**HIGHLANDS COUNTY BOARD OF COUNTY  
 COMMISSIONERS (HCBCC)  
 PURCHASING DIVISION  
 600 S. Commerce Ave  
 Sebring, FL 33870  
 (863) 402-6500**

DATE: April 3, 2024  
 BID NO. 23-030-KSB                      ADDENDUM No. 4  
 Project.: Highlands County Solid Waste Management Center Class I Cell 5 Landfill  
 Expansion Highlands County Project No. 21078

HIGHLANDS COUNTY SOLID WASTE  
MANAGEMENT CENTER  
CELL 5 LANDFILL EXPANSION  
HIGHLANDS COUNTY, FLORIDA

PROJECT SITE PLAN AND KEY MAP

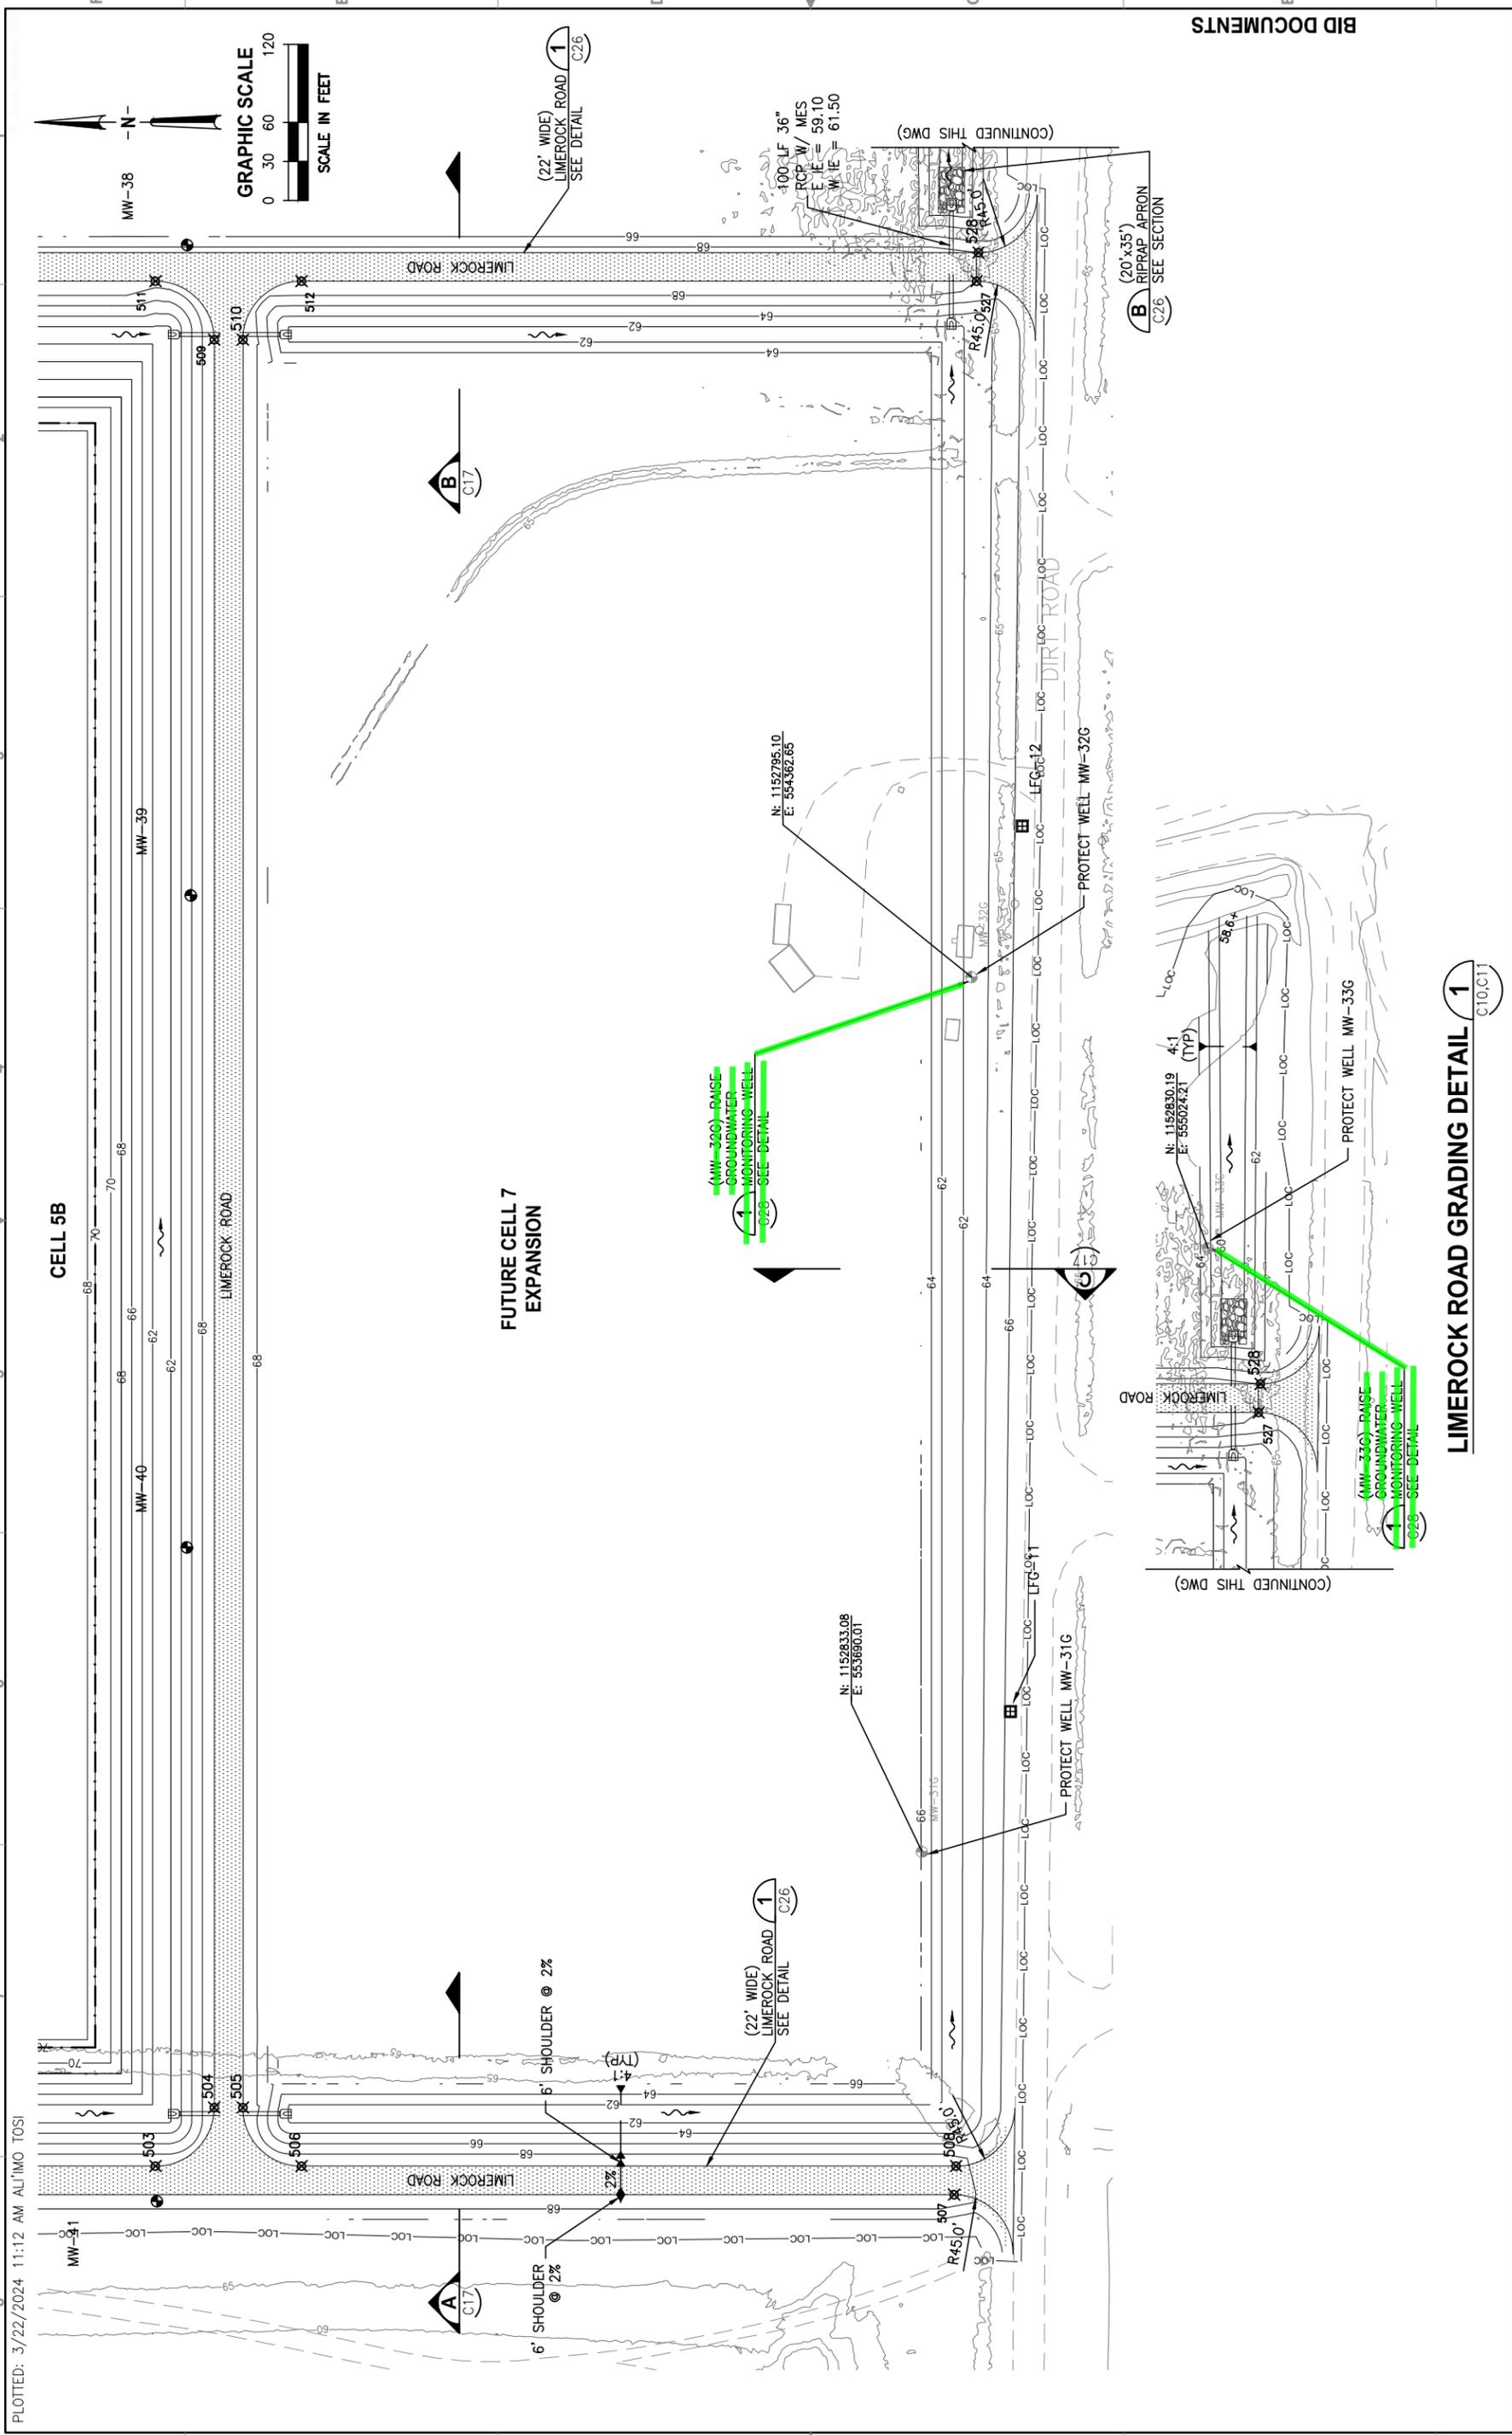
delivering a hard copy of the bid, is it acceptable to package the bid bond with the bid or should it be packaged separately and delivered prior to submission of the bid?
<b>A2</b>	<b>See page 5, Section 00010-1, Invitation to Bid. The bond may be included with the hard-copy submission package.</b>
<b>Q3</b>	The "Statement of Indemnification" form to be submitted with the bid includes the Florida Department of Transportation (FDOT). Will this statement of indemnification apply to FDOT?
<b>A3</b>	<b>Division 0, Section 00160-8, Certificates and Forms, relating to "Florida Department of Transportation (FDOT)" is to be removed from the solicitation package. This is not applicable to this project.</b>
<b>Q4</b>	Where should the Contractor plan to stockpile material stripped from the Cell 5 footprint?
<b>A4</b>	<b>This material shall be stockpiled to the east of the dewatering area. Drawing C2 has been revised to indicate the location of this stockpile. Please note that this material will become the property of the Owner for their use. Additionally, the Owner may elect to strip this material themselves prior to the beginning of work by the Contractor. The Contractor shall install a silt fence around the stockpile meeting the requirements of Drawing EC3. Attachment 1.a provides Revised Drawing C2. Attachment 1.b provides redline markups showing the revisions to the Drawing C2.</b>
